NAC-LWT

CoC No. 9225

Addition of Segmented TPBARs in a
TPBAR Waste Container as Approved
Content

NAC Amendment Application

Figure 1.2-14 TPBAR Waste Container and Extension Weldment Sketch

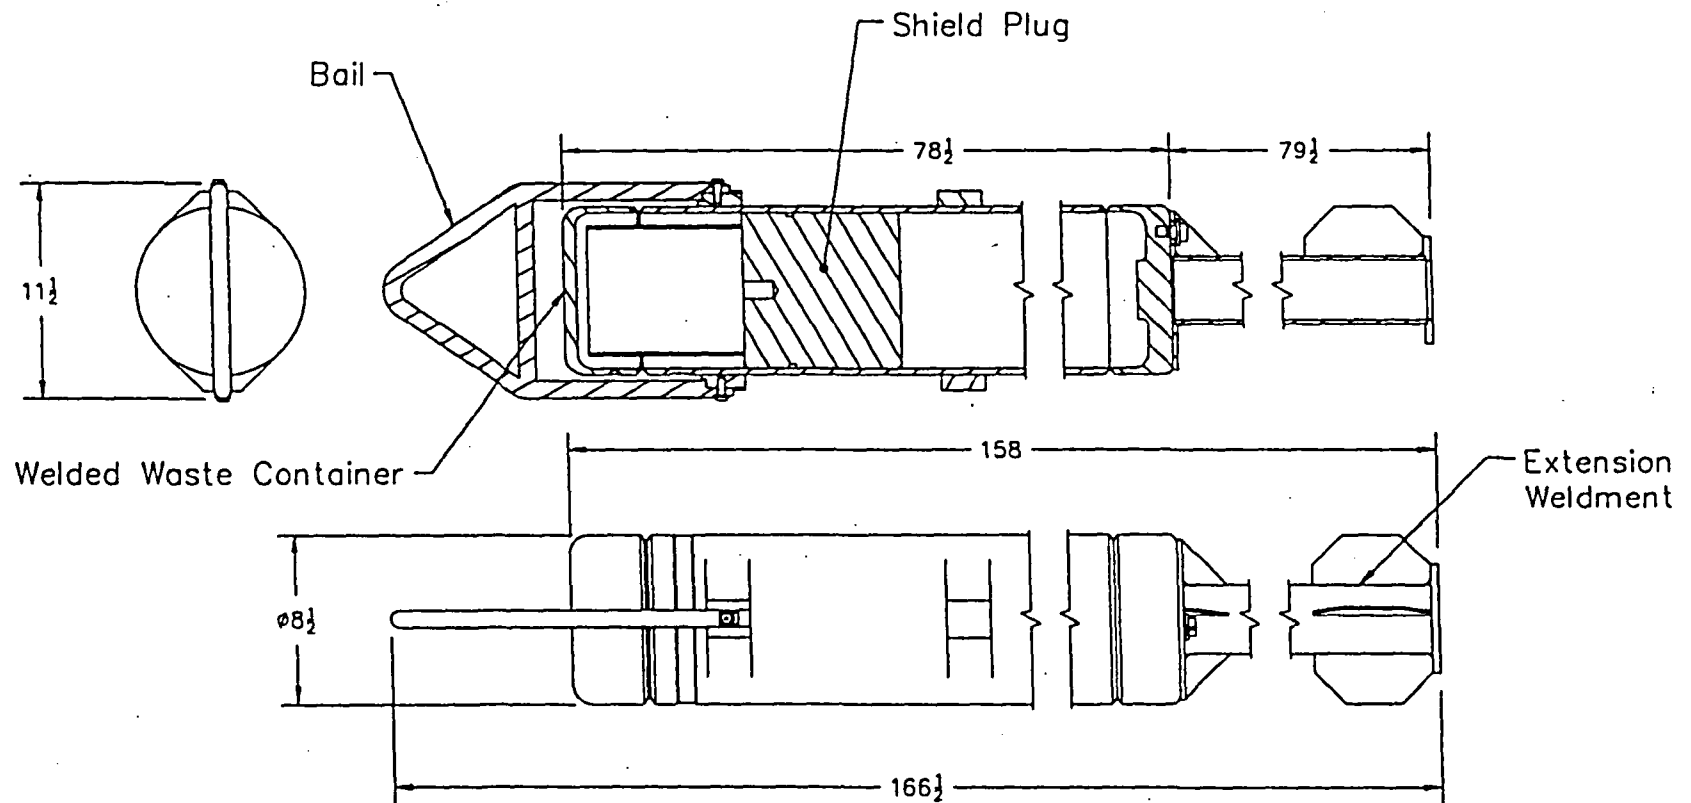
- **NAC-LWT SAR, Revision LWT-06B**
- **Content Change** – Added up to 32 Segmented TPBARs, incl. Segmentation debris from PIE; Added Procedural Controls to Prevent Spread of Tritium Contamination; Updated Unclassified DOE Reference Documents and Drawings
- **Shipping Configuration Change** – Added TPBAR Waste Container (stainless steel, welded construction); Added Top Insert to TPBAR Consolidation Canister Sketch
- **Non-TPBAR Related Changes** – Drawing Update, Editorial Changes
